CTC + AAC BP07 Core & Shell Group 2

ADDENDUM #1

## Addendum #01

| Project | UK CTC BP-07 Core and Shell Group 2 | UK Project #       | 2563.0     |

SHEET NO.  
**A473.A**

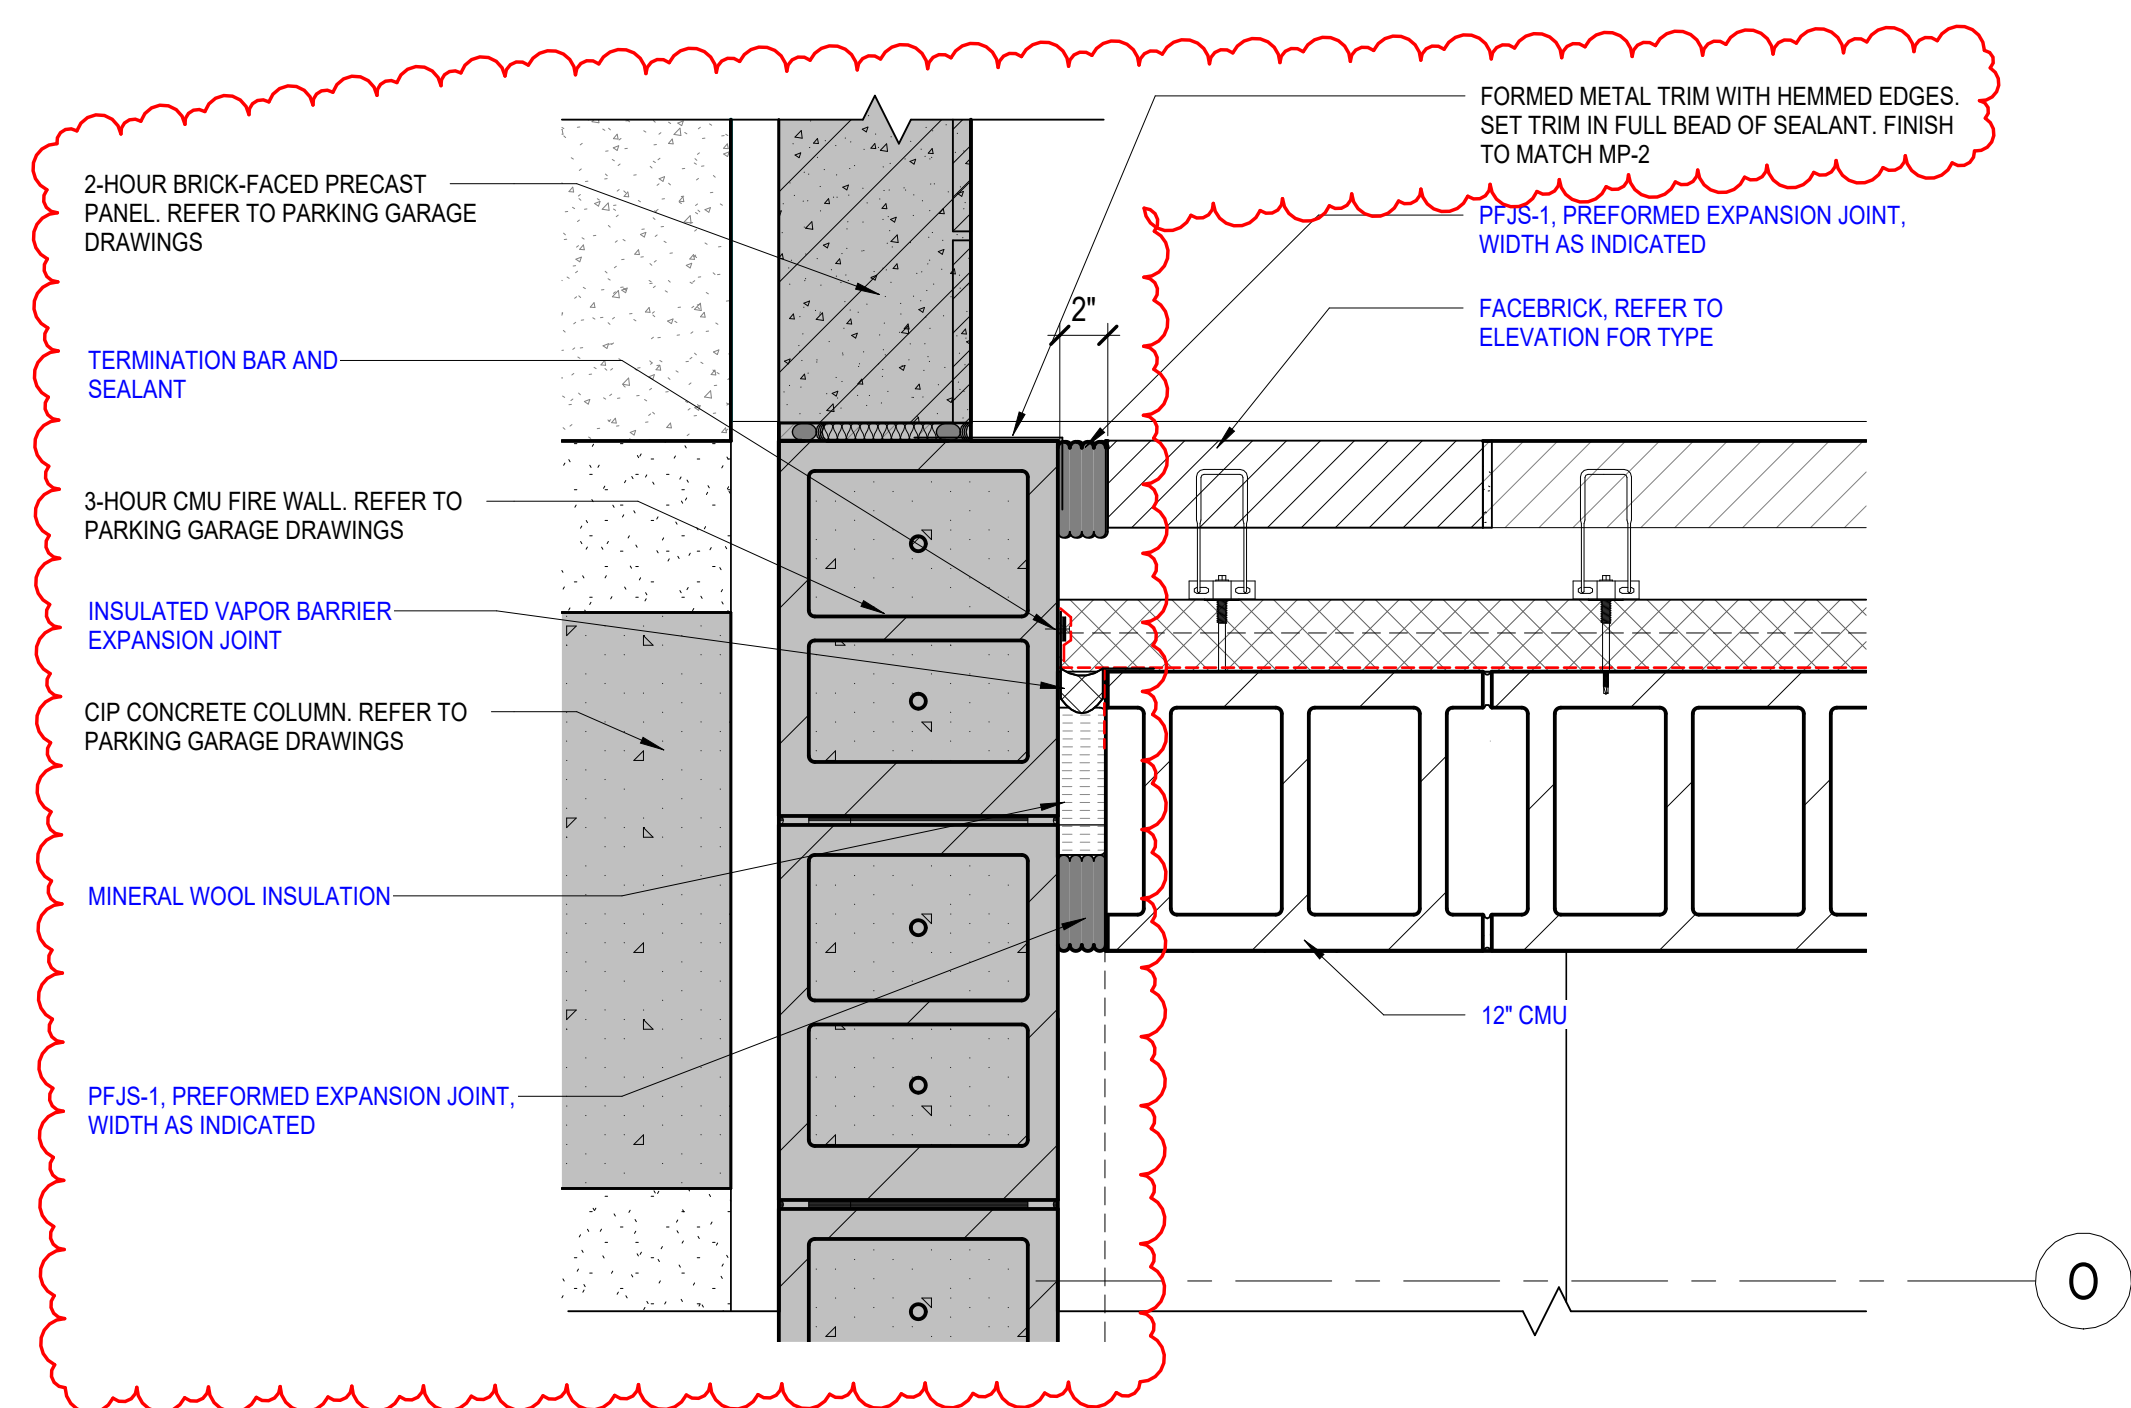
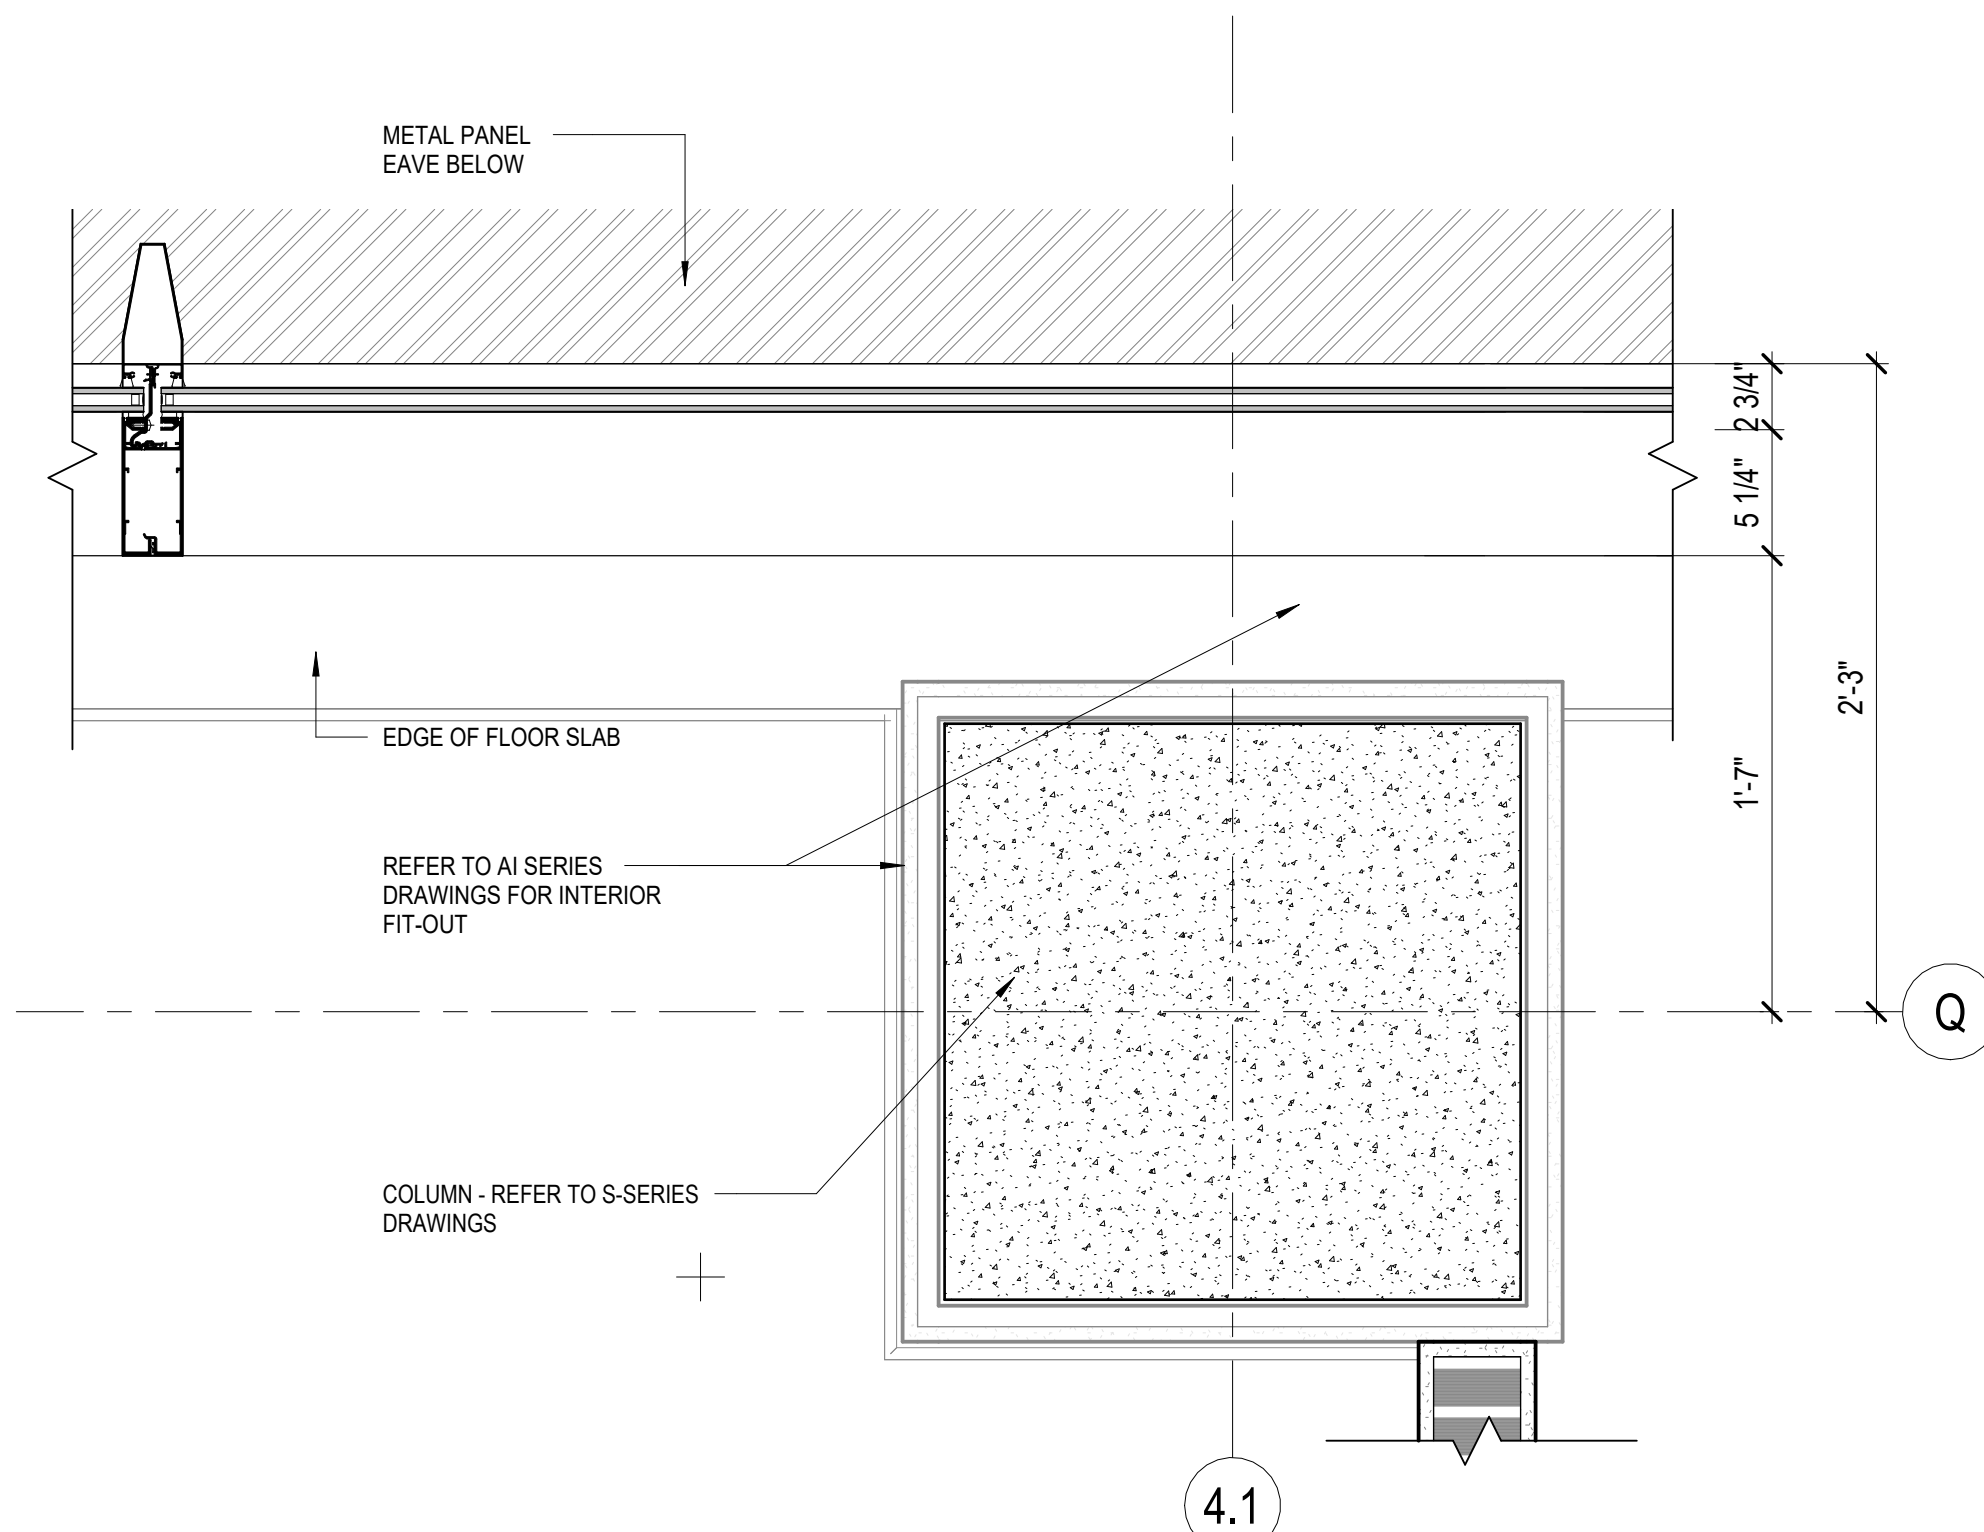
**A473.D – EXTERIOR PLAN DETAILS**

1. Revised details 7 and 8 to coordinate with fire wall in parking garage.

**1 SHELL & CORE POWER PLAN - PENTHOUSE LEVEL - AREA A**  
SCALE: 1/8" = 1'-0"

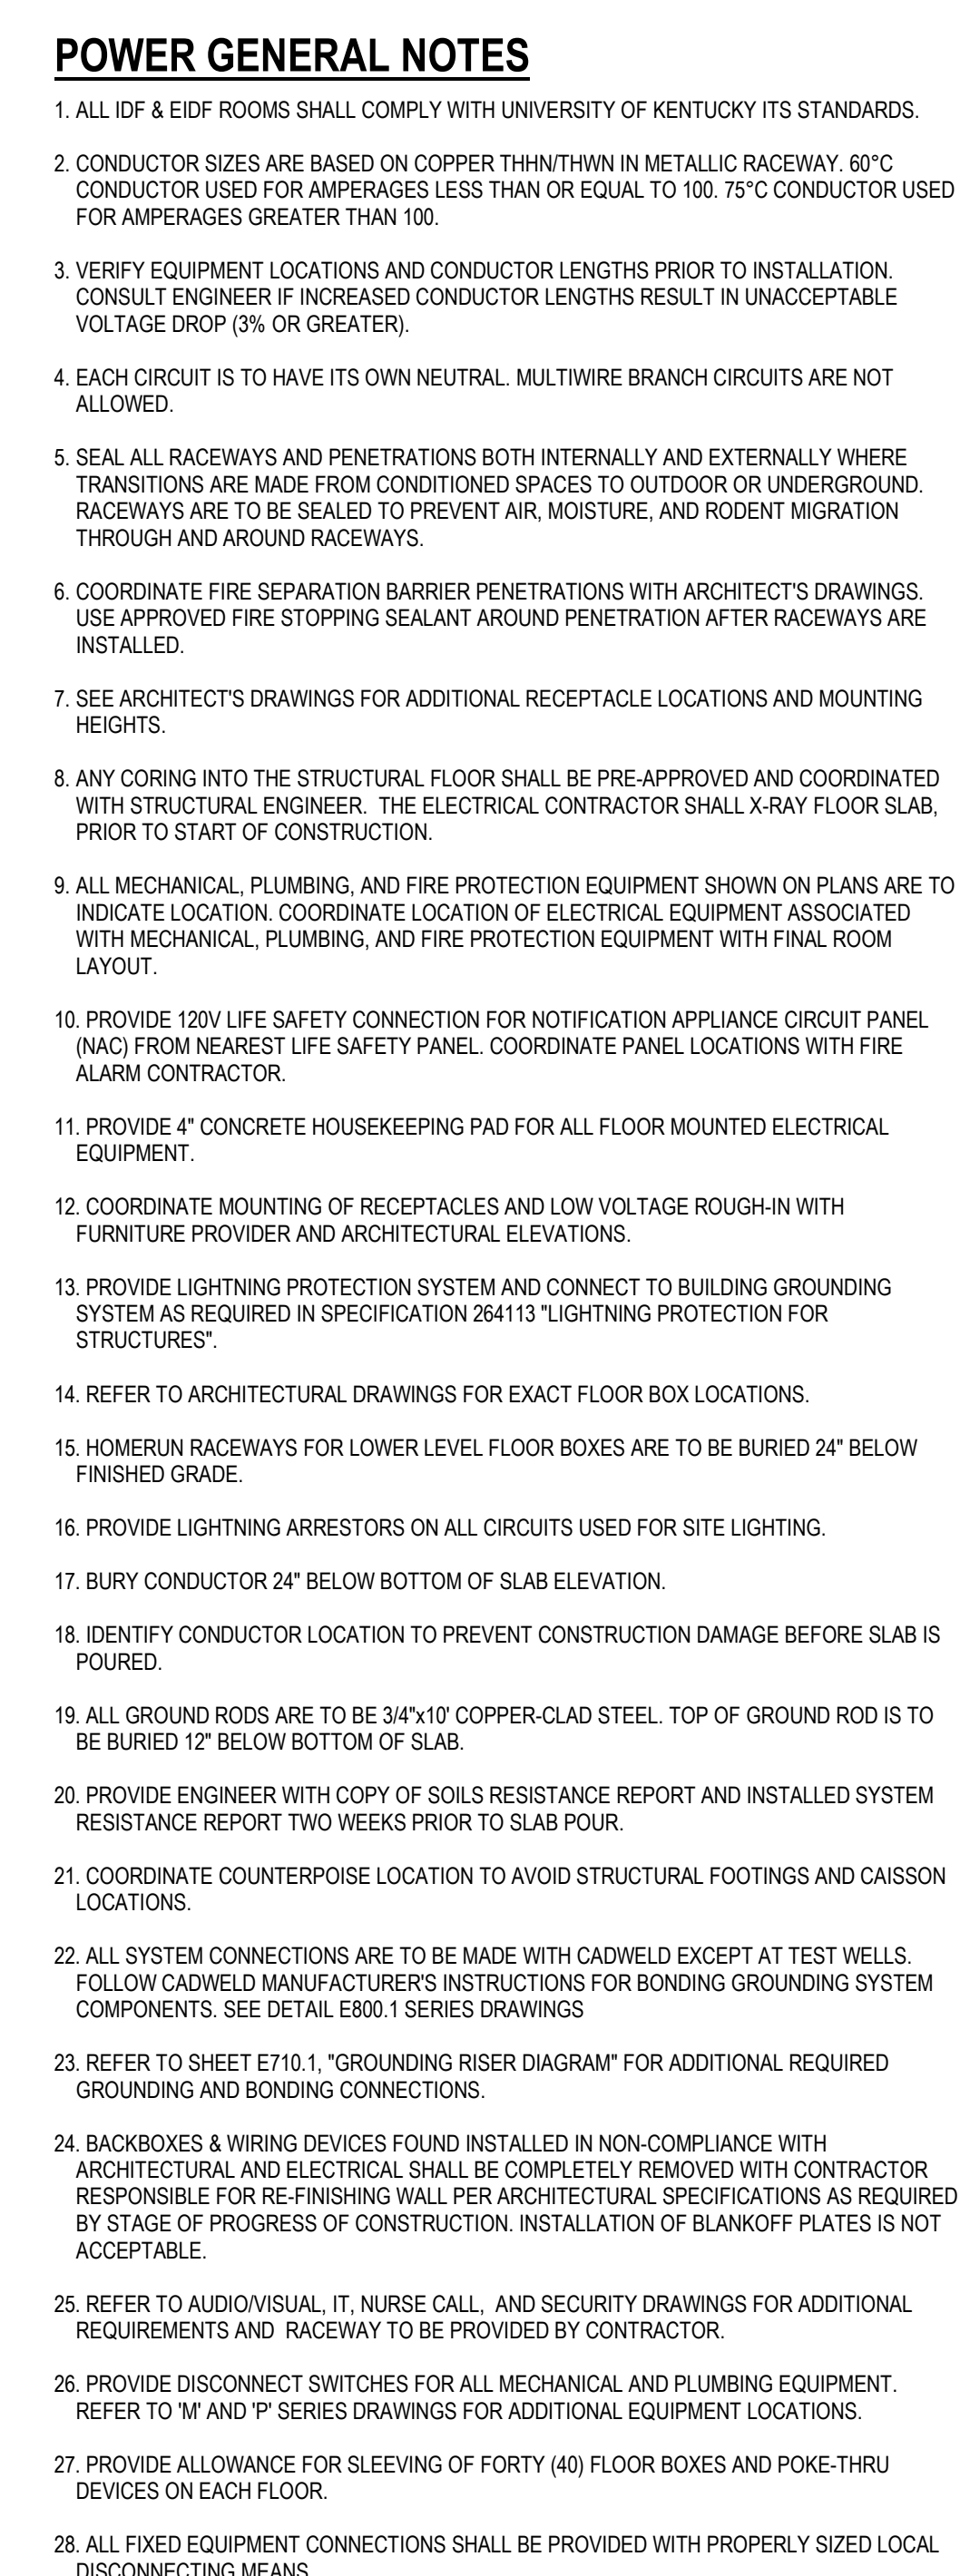
**E308.A – SHELL AND CORE POWER PLAN – PENTHOUSE LEVEL – AREA A**

1. New drawing. Already listed on drawing index.
